February 13, 2020

**Re: US Eagle FCU Juan Tabo**  
**1955 Juan Tabo Blvd. NE**  
**Traffic Circulation Layout**  
Engineer's/Architect's Stamp 11-21-2019 (H21D029)

Based upon the information provided in your submittal received 02-07-2020, the above referenced plan cannot be approved for Building Permit until the following comments are addressed:

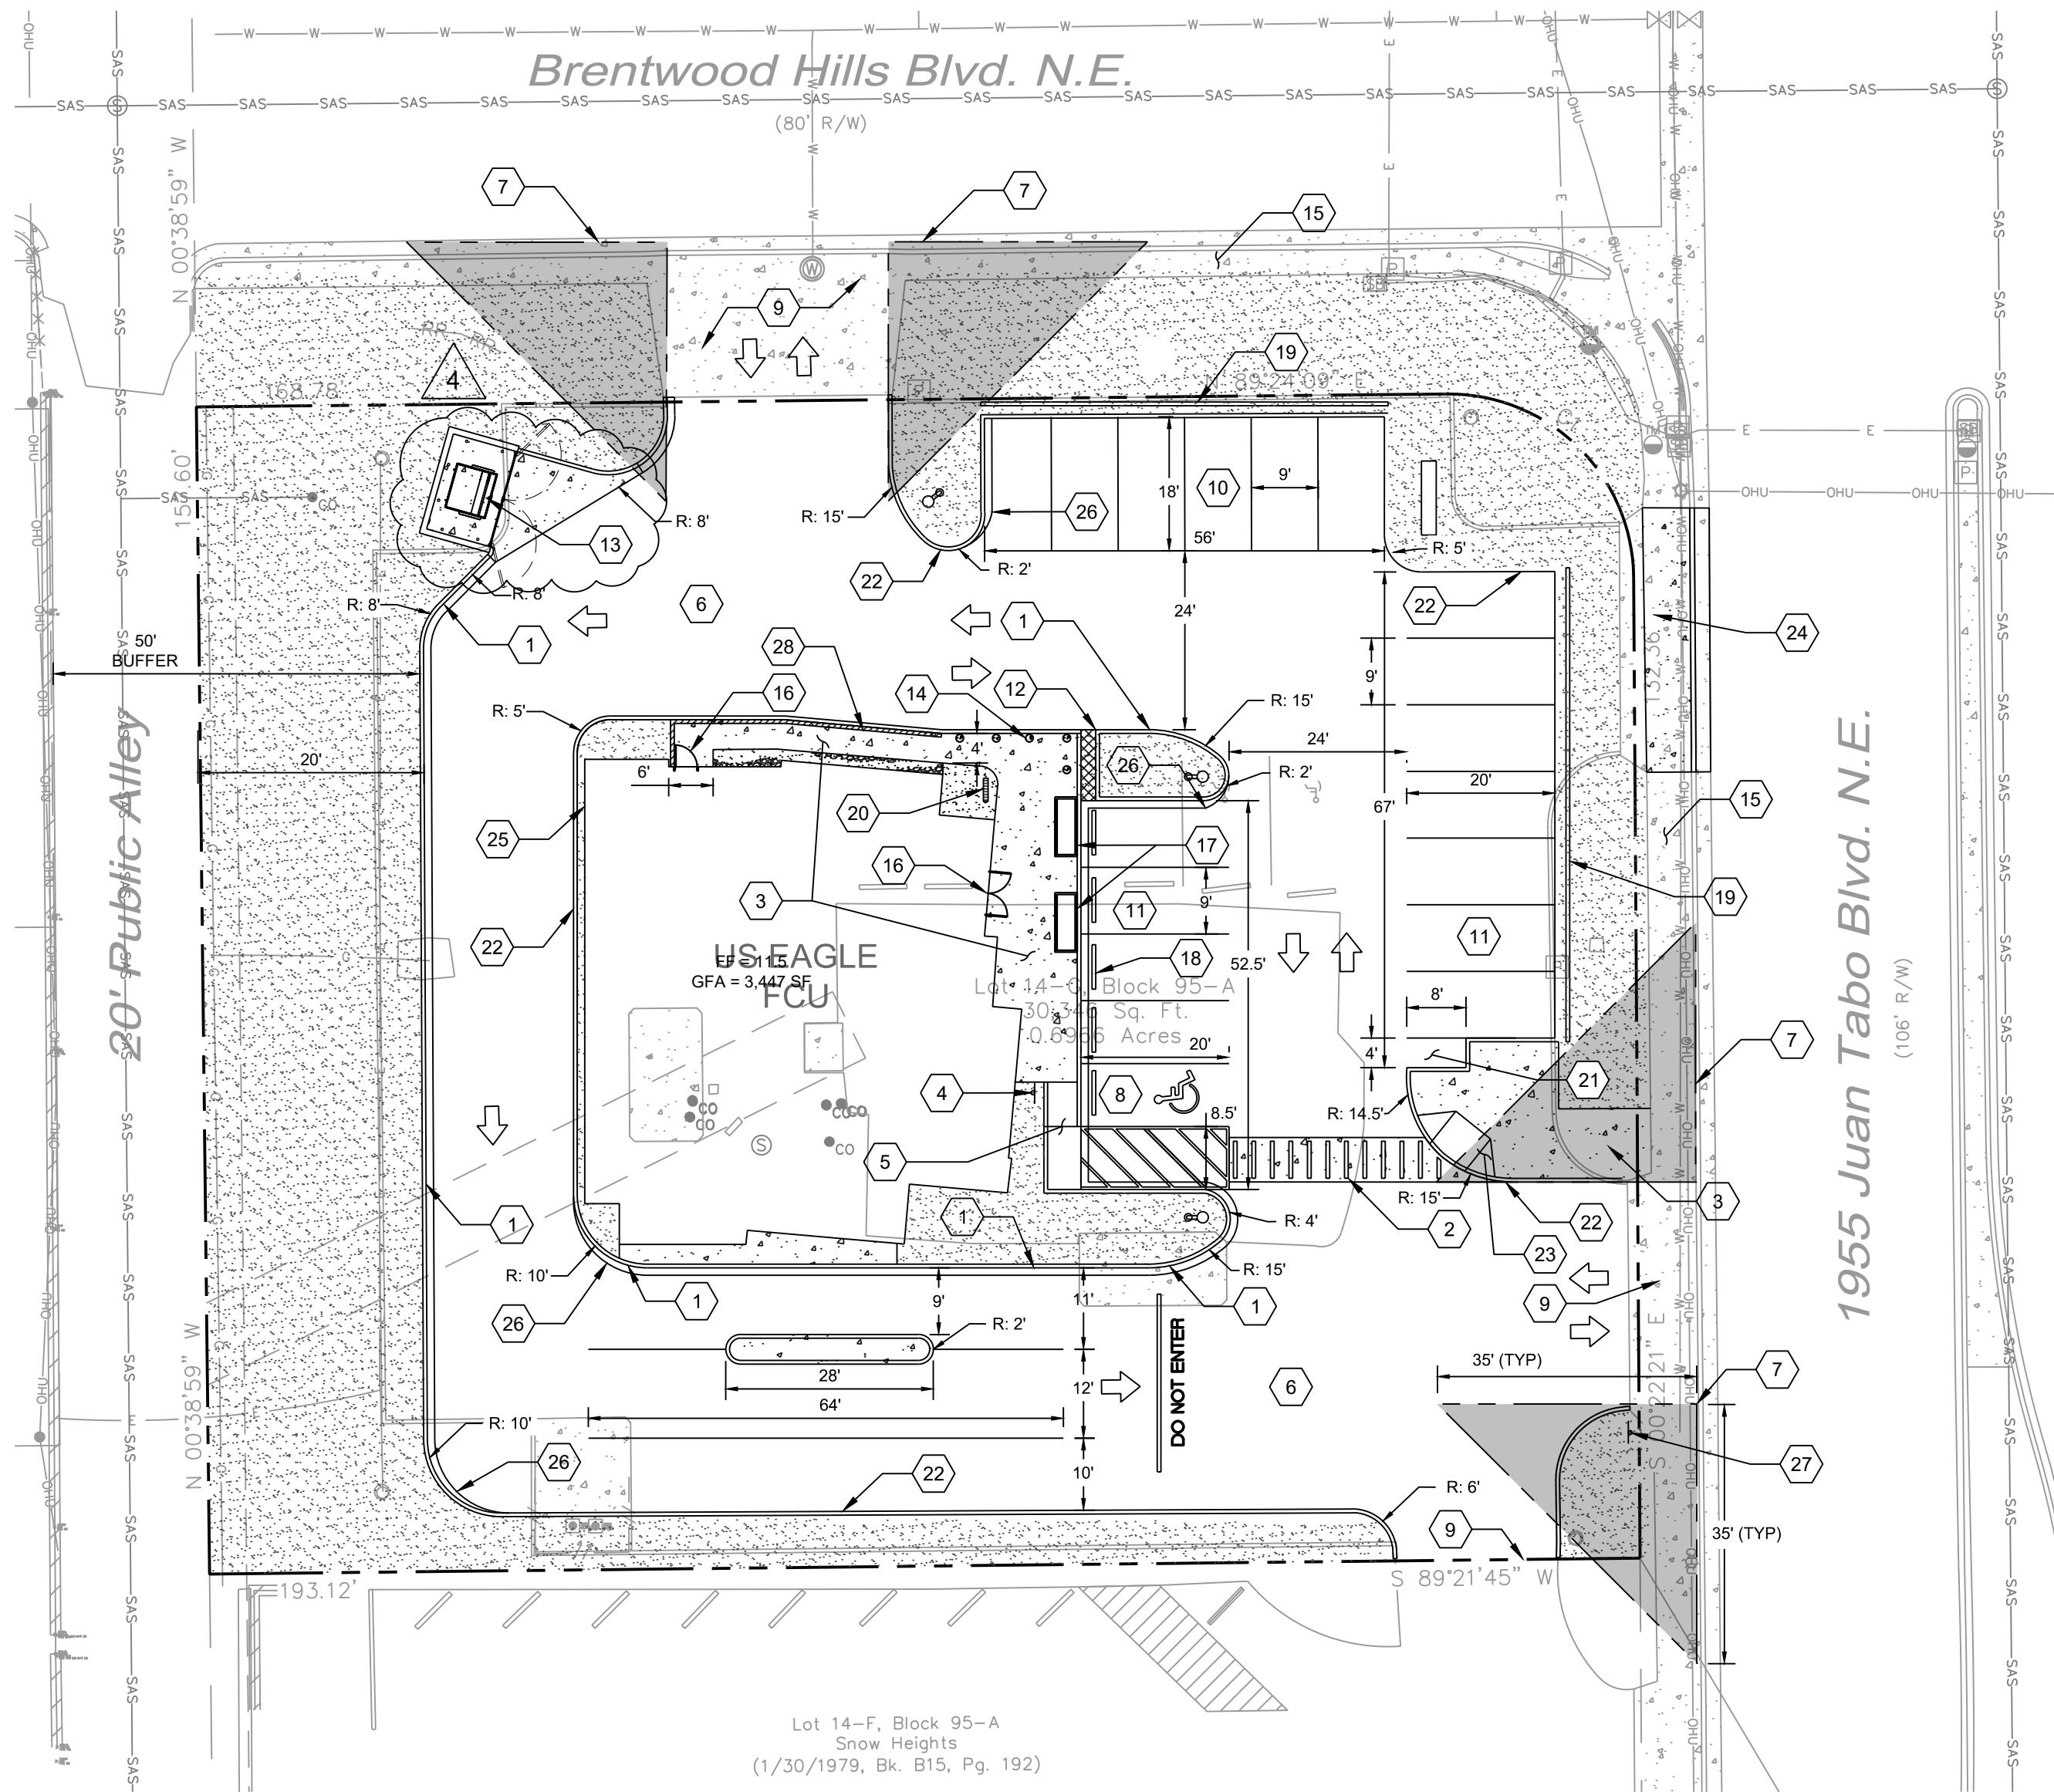
1. List the number of parking spaces including bicycle and motorcycle parking required by the zoning code.
2. The ADA accessible parking sign must have the required language per 66-7-352.4C NMSA 1978 **"Violators Are Subject to a Fine and/or Towing."** Please call out detail and location of signs. Please include the detailed sheet.

3. The ADA access aisles shall have the words **"NO PARKING"** in capital letters, each of which shall be at least one foot high and at least two inches wide, placed at the rear of the parking space so as to be close to where an adjacent vehicle's rear tire would be placed. (66-1-4.1.B NMSA 1978)

4. ADA curb ramps must be updated to current standards and have truncated domes installed.
5. Motorcycle parking spaces shall be designated by its own conspicuously posted upright sign, either free-standing or wall mounted per the zoning code.

6. All bicycle racks shall be designed according to the following guidelines:
  - a. The rack shall be a minimum 30 inches tall and 18 inches wide.
  - b. The bicycle frame shall be supported horizontally at two or more places. Comb/toaster racks are not allowed.

- c. The rack shall be designed to support the bicycle in an upright position. See the IDO for additional information.
  - d. The rack allows varying bicycle frame sizes and styles to be attached.

- e. The user is not required to lift the bicycle onto the bicycle rack.
  - f. Each bicycle parking space is accessible without moving another bicycle.

7. Bicycle racks shall be sturdy and anchored to a concrete pad.
8. A 1-foot clear zone around the bicycle parking stall shall be provided.
9. Bicycle parking spaces shall be at least 6 feet long and 2 feet wide.

10. The 9' drive-thru lane is too narrow.
11. Per the IDO, a 6 ft. wide ADA accessible pedestrian pathway is required from the public sidewalk to the building entrances. Please clearly show this pathway and provide details.

12. Refuse vehicle maneuvering shall be contained on-site. The refuse vehicle shall not back into the public right of way.; **provide a copy of refuse approval.**

13. All one-way drives shall have "One Way" and "Do Not Enter" signage and pavement markings. Please show detail and location of posted signs and striping.

14. Shared Site access: driveways that straddle property lines, or are entirely on one property but are to be used by another property, shall have an access easement. Please include a copy of your shared access agreement with the adjacent property owner.

15. The alley needs to be improved.
16. Work within the public right of way requires a work order with DRC approved plans.
17. Please add a note on the plan stating "All improvements located in the Right of Way must be included on the work order."

18. Add a note stating "All broken or cracked sidewalk must be replaced with sidewalk and curb & gutter." A build note must be provided referring to the appropriate City Standard drawing.
